**REPORT OF: URBAN DESIGN COMMISSION****PRESENTED:** September 17, 2014**TITLE:** 202 East Washington Avenue –  
Redevelopment of the “Pahl Tire” Site for  
a 10-Story, 146-150 Room “AC Hotel by  
Marriott” in UDD No. 4, 2<sup>nd</sup> Ald. Dist.  
(33109)**REFERRED:****REREFERRED:****REPORTED BACK:****AUTHOR:** Alan J. Martin, Secretary**ADOPTED:****POF:****DATED:** September 17, 2014**ID NUMBER:**

**REQUEST FOR HEIGHT MAP MODIFICATION**

# Exhibit D

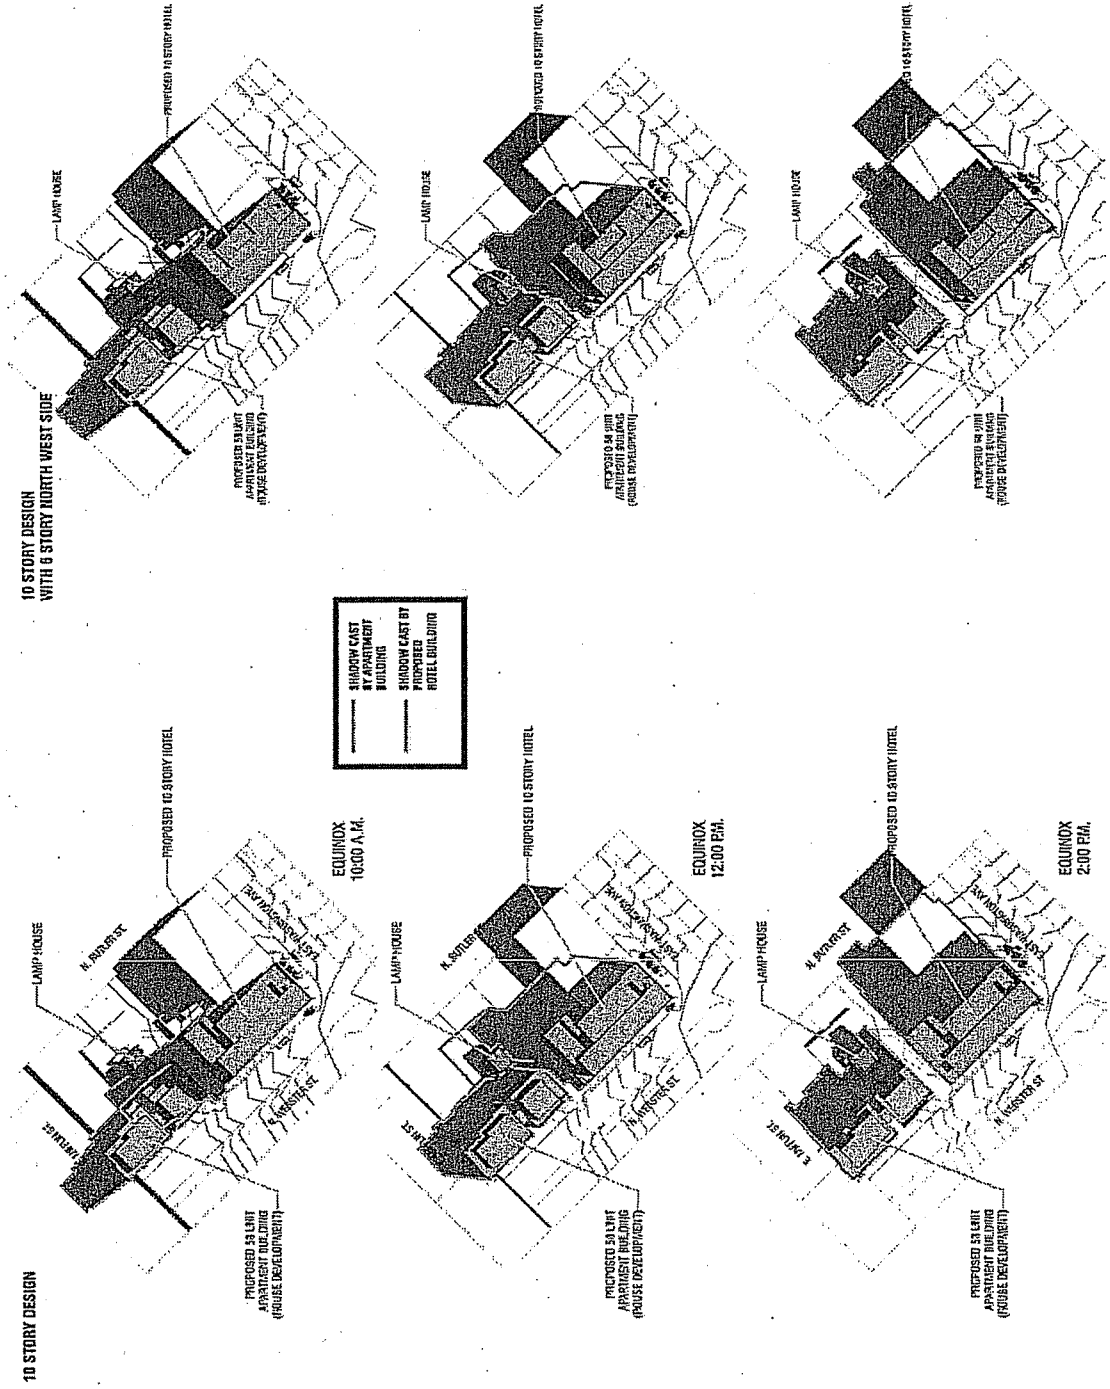
- The standards for excess height are not met. The biggest thing for me is the standards say the excess height "is compatible with the existing or planned character of the surrounding area," and I cannot find that to be the case.
- I also think these shadow studies are not great.
